LAND USE APPLICATION SUMMARY

Property Location: 4537 3rd Ave S
Project Name: Church of St. Joan of Arc Addition
Prepared By: Janelle Widmeier, Senior City Planner, (612) 673-3156
Applicant: Church of St. Joan of Arc
Project Contact: Michele Foster
Request: To construct an addition to a place of assembly.
Required Applications:

St. Joan of Arc Gathering Space Project Description and Variance Statement September 2, 2016

1 ARCHITECTURAL SITE PLAN
1" = 20'-0"

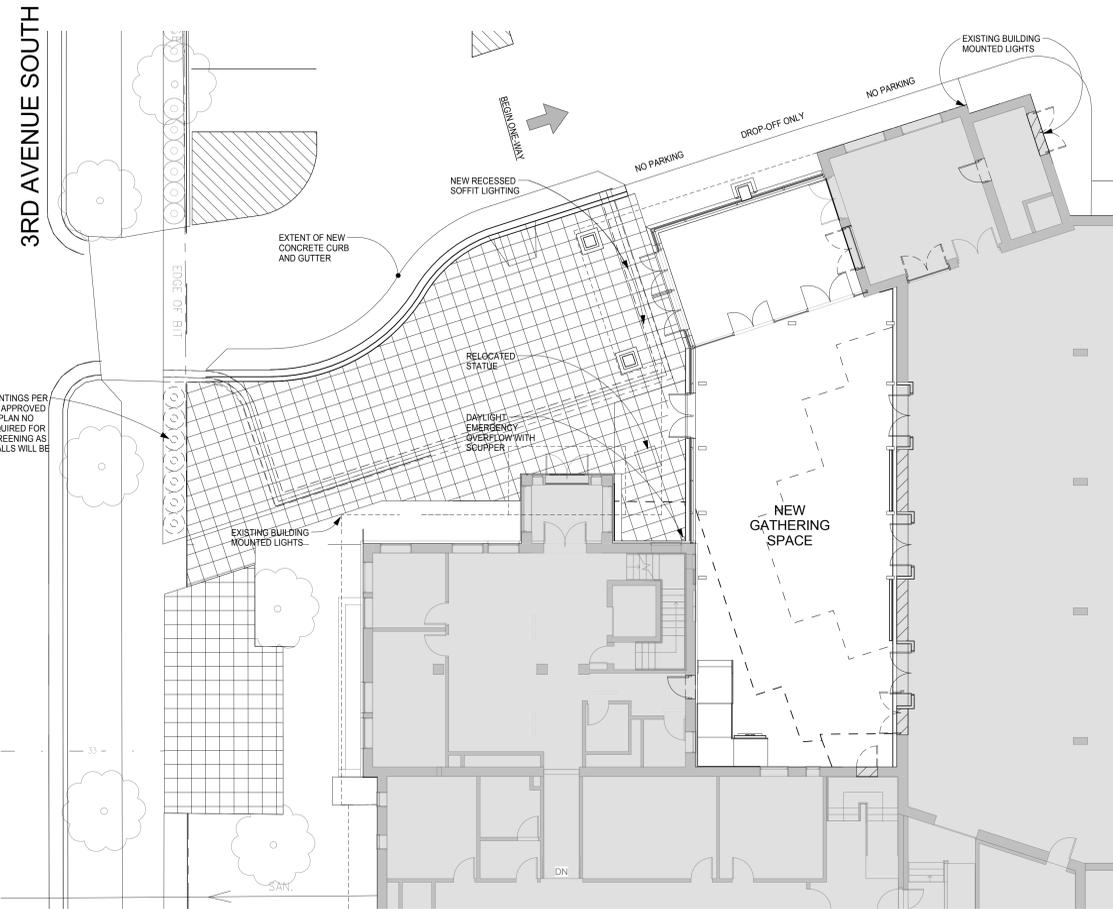
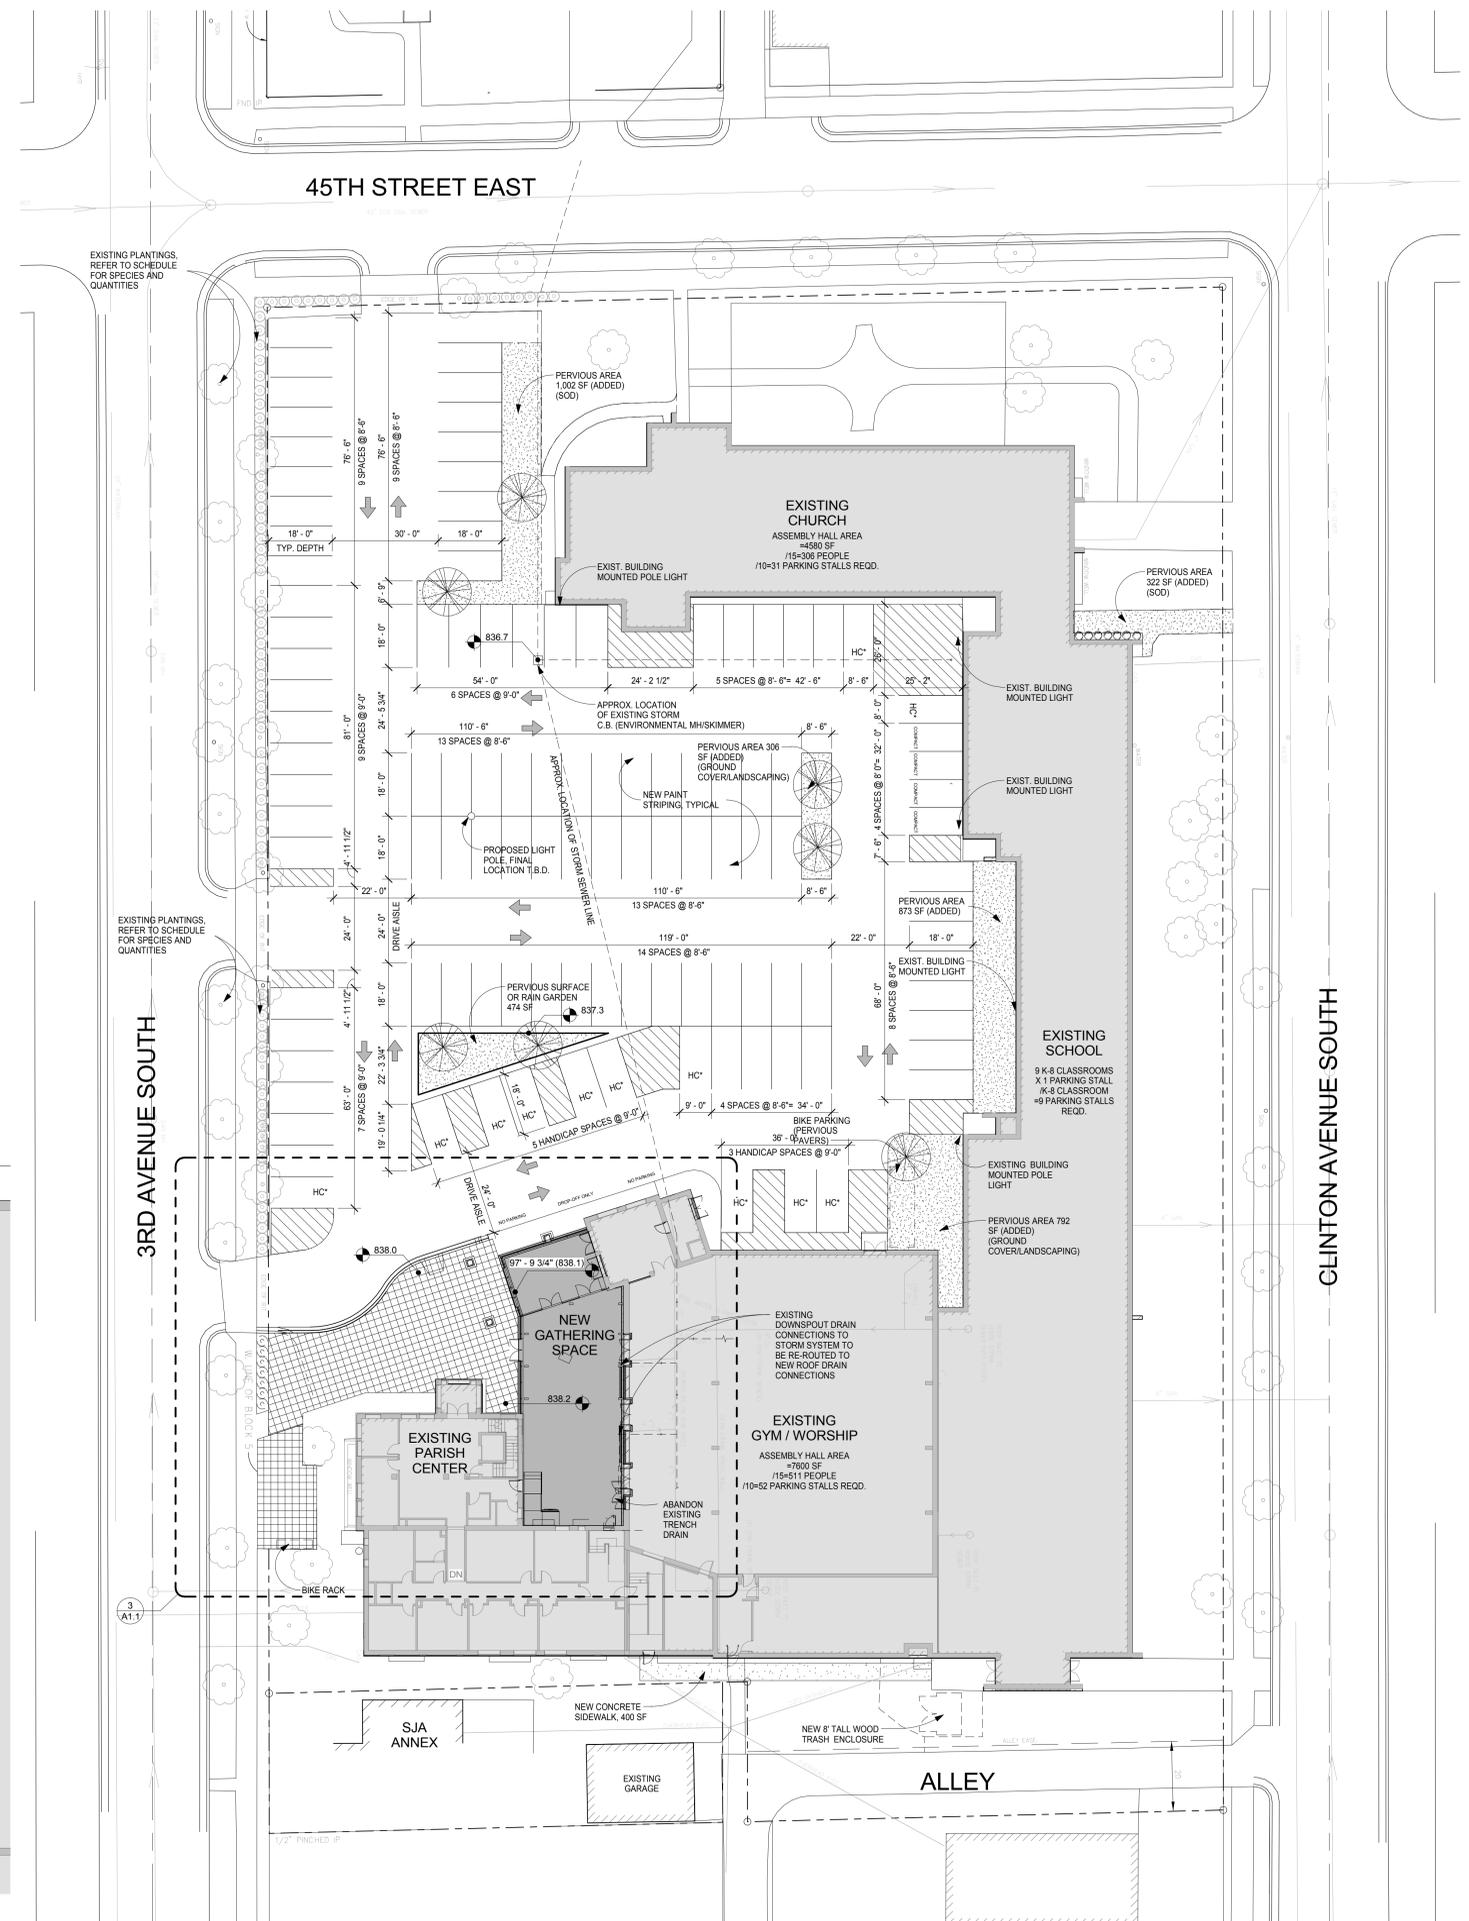
- Utility Connections: A note on Sheet A1.1 indicates, "Existing downspout drain connections to storm system to be re-routed to new roof drain connections". Please identify where these new connections are proposed to tie into and where that system discharges to the City storm sewer.
